In Reply Quote S/B NMD-55-12
Revision 1
4th December, 1980

SUBJECT: NOMAD SERVICE BULLETIN NMD-55-12 REVISION 1

SUBJECT: HORIZONTAL STABILISER - INTRODUCTION OF BALANCED TRIM TABS (MODIFICATION N439)

FIGURE 2

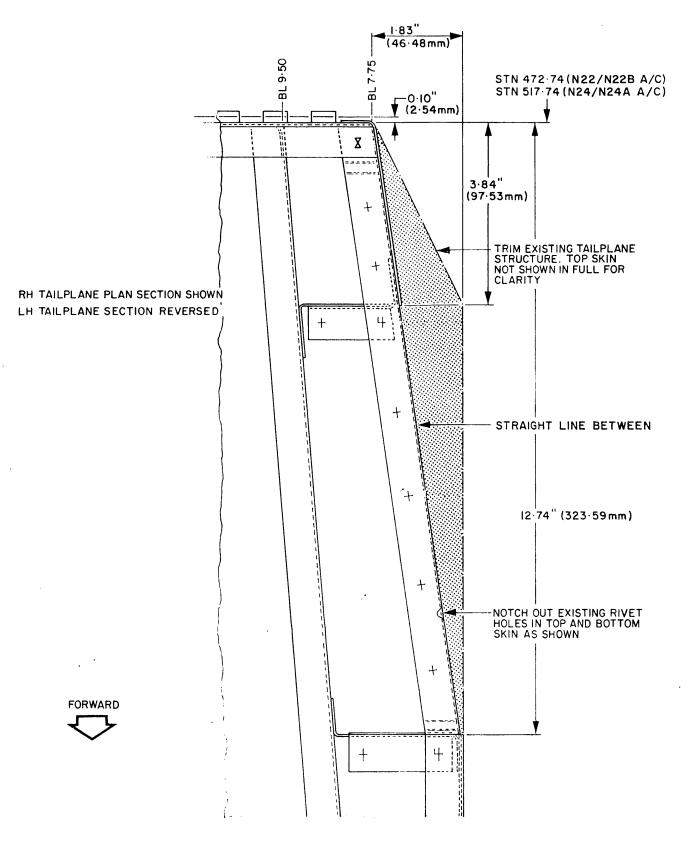
- (2) Trim off the upper and lower skins inboard of the horizontal stabiliser LH and RH inboard ribs (Ref Figs 1 and 2).
- (3) Assemble and rivet diaphragms and angles to the LH and RH inboard ribs (Ref Figs 1 and 4).

FIGURE 3

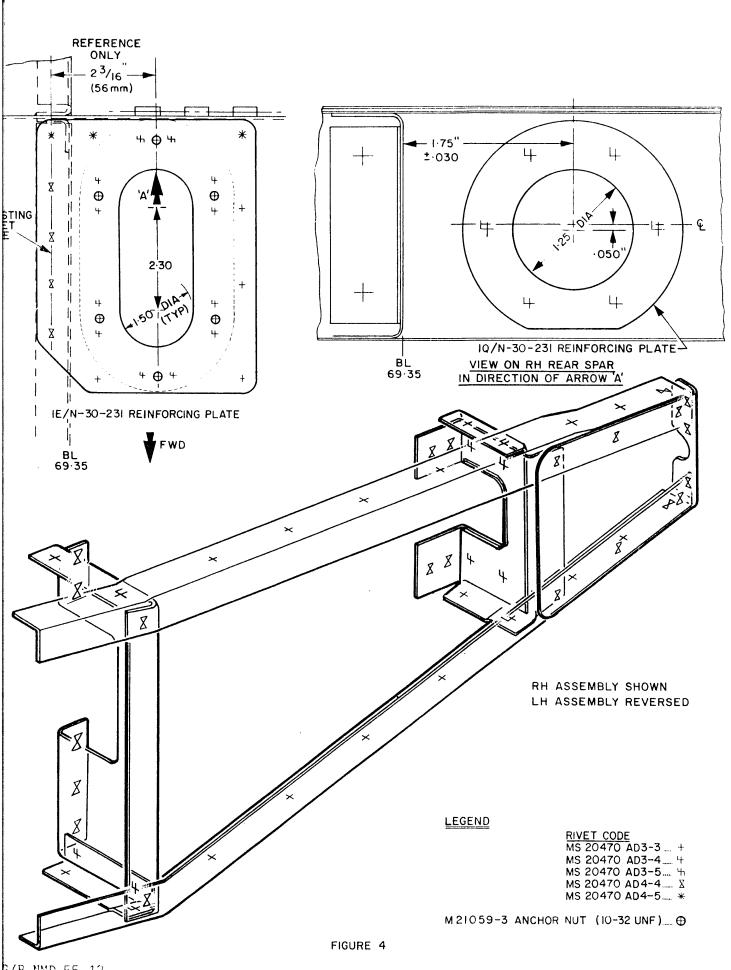
- (12) Page 6, Para 2, Part B (6).
 Reference to removing the trim tabs immobilising device added.
- (14) Page 9, Figure 3. Part No's 1K, 1L, 1M and 1N/N-30-231 changed to 1A, 1B, 1C and 1D/NR12126 respectively.
- (15) Page 11, Para 3.A.(1).
 Part No NMD-55-12-1 added after Part A Kit.
 Part No's 1K, 1L, 1M and 1N/N-30-231 changed to
 1A, 1B, 1C and 1D/NR12126 respectively.
- (16) Page 11, Para 3.A.(2).
 Part No NMD-55-12-2 added after Part B Kit.
- (17) Page 12, Para 3.B NOTE.

NOTE: The parts shown in detail B of Fig 2 of S/B NMD-55-10 are removed and replaced by Part Nos. 1A/NR12126, 1B/NR12126, and 1C/NR12126 and 1D/NR12126 (Ref Figures 1 and 3 of this bulletin).
